Docket Number:	18-IRP-01
Project Title:	Integrated Resource Plan
TN #:	229422
Document Title:	Staff Paper - Review of Imperial Irrigation District's 2018 Integrated Resource Plan
Description:	N/A
Filer:	Harinder Kaur
Organization:	California Energy Commission
Submitter Role:	Commission Staff
Submission Date:	8/14/2019 3:57:16 PM
Docketed Date:	8/14/2019

Review of Imperial Irrigation District's 2018 Integrated Resource Plan

August 2019 | CEC-200-2019-012

Figure 1: Imperial Irrigation District and CEC Energy Forecasts 2018-2030 (GWh)

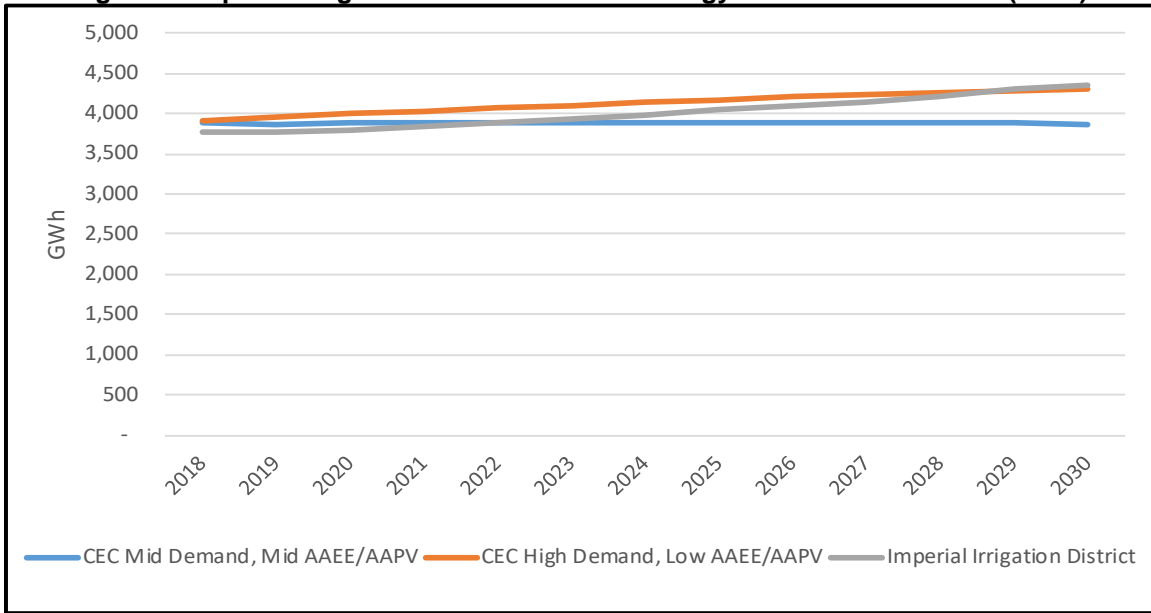
IID's energy demand forecast (expected case) is similar to the CEC's demand forecasts (*California Energy Demand 2018 to 2030 Revised Forecast*).¹² The IID forecast lies between the CEC's *mid demand forecast* that includes mid-levels of additional achievable energy efficiency (AAEE) and additional achievable photovoltaic (AAPV) and the *high demand forecast* that includes low levels of AAEE and AAPV.¹³ IID's energy demand forecast projects a 1.2 percent annual average increase in load from 2019 to 2030, with its forecast closer to the CEC's *mid demand forecast* from 2019 to 2023, and growing closer to the *high demand forecast* from 2024 to 2030.

By 2030, the IID energy demand forecast is almost identical to the CEC's *high demand forecast*; IID's forecast is 39 gigawatt-hours (GWh) higher in 2030, less than a 1 percent difference. In the same year, IID's energy demand forecast is 485 GWh higher than the CEC *mid demand forecast*, a 12 percent difference that is adequate in a long-term planning context. **Figure 1** compares IID's energy demand forecast to those of the CEC.

Figure 2: Imperial Irrigation District and CEC Peak Forecasts 2018 - 2030 (MW)

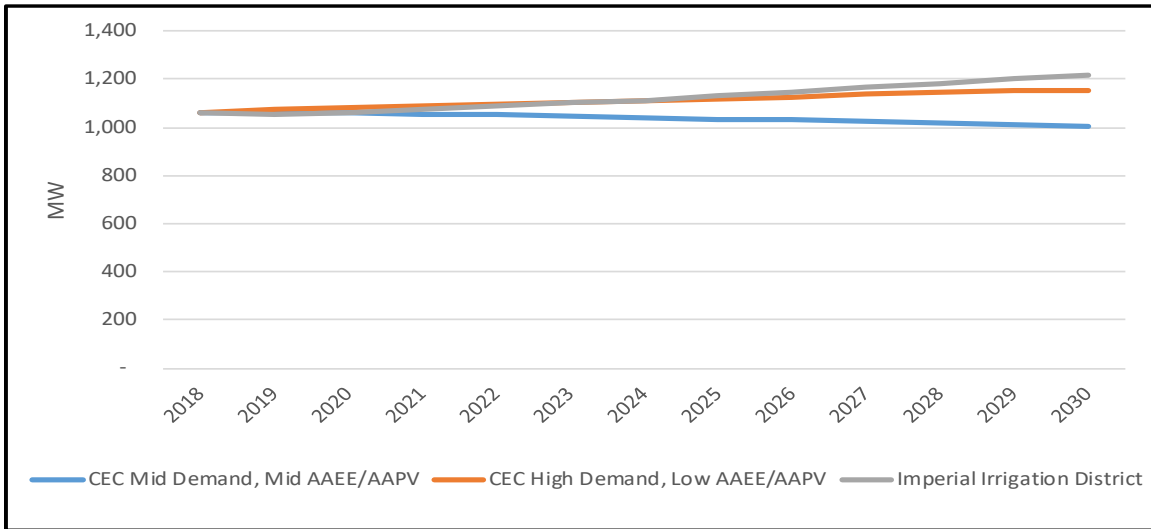
The utility's peak demand forecast is almost identical to the CEC *high demand peak forecast* from 2018 to 2025, then starts to exceed it from 2026 to 2030. IID planned for the possible influx of large commercial customers into its service area, which would increase its load, and may explain why IID's demand forecasts are closer to the CEC high demand forecasts. By 2030, IID's peak demand forecast is 64-MW, or about 5 percent,

higher than the CEC's *high demand peak forecast*. This difference is adequate in a long-term planning context.

Figure 4: Imperial Irrigation District Renewables Portfolio Standard Mix in 2019 and 2030

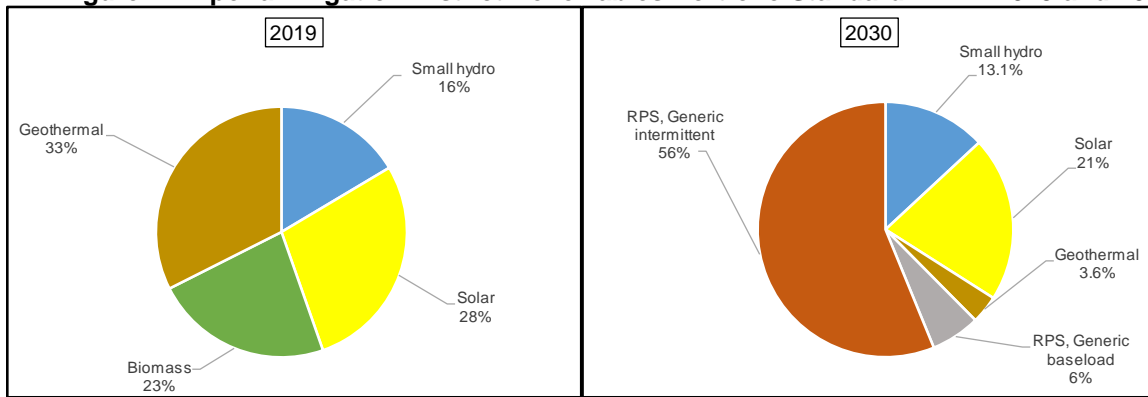
As shown in **Figure 4**, in 2019, the utility has roughly 70 percent baseload and 30 percent intermittent renewable resources. By 2030, IID's renewable resource mix consists mostly of contracted resources, and new renewables procured in 2029-2030 are roughly 90 percent intermittent and 10 percent baseload. IID's renewable resource mix, in 2030, includes:

In 2030, IID does not plan to receive any energy from specific biomass or wind resources. The utility plans to use its energy storage resources, existing natural gas power plants, and spot-market purchases and sales, to integrate its renewable energy resources. The resources IID plans to procure in 2029-2030 provide RECs to meet its RPS requirements and add diversity to its renewable resource portfolio.
